January 24, 1996

Subject: Waiver Justification Document

Triassic Park Waste Disposal Facility

Chaves County, New Mexico

SUGGESTED LANDFILL LINER DESIGN TRIASSIC PARK WASTE DISPOSAL FACILITY

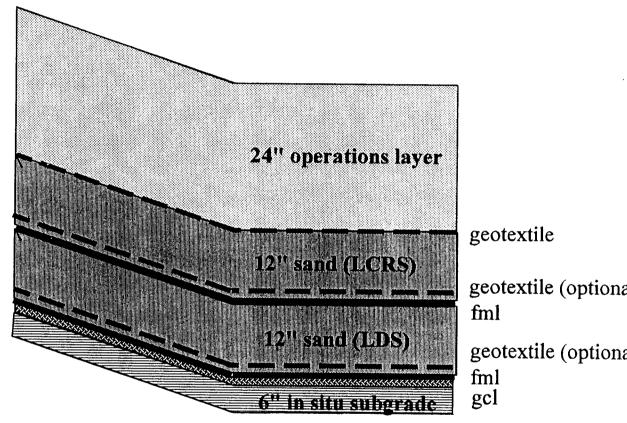
In consideration of all the aforementioned comments, the Department suggests the following approach be modeled and compared to the RCRA specified liner. In reference to Figure 2-9 of the application, delete the 2 foot clay layer beneath the upper FML. Under the lower drainage layer place an FML with geosynthetic clay liner This configuration along with the upper FML should be extended to the top of the slopes and terminated in a suitable anchorage (a sketch is attached for clarification). The composite liner design (FML & GCL) has been shown to be equivalent in costs to 2 feet of constructed clay liner. Therefore, the level of protection should increase without a substantial increase in cost. This configuration is presented only as a suggestion for your review and analysis and is not intended to preclude other configurations or indicate it is an approvable design.

Regarding the placement of any geosynthetic liner material, the Department requires it be placed, at a minimum, on six inches of prepared subgrade compacted to 90% Standard Proctor Density, the surface of which is free of stones greater than 1/2-inch in any dimension, organic matter, local irregularities, protrusions, loose soil, and any abrupt changes in grade that could damage the geosynthetic. The alternate liner analysis could then consider the bottom six inches as a component of the liner provided its construction meets the design criteria.
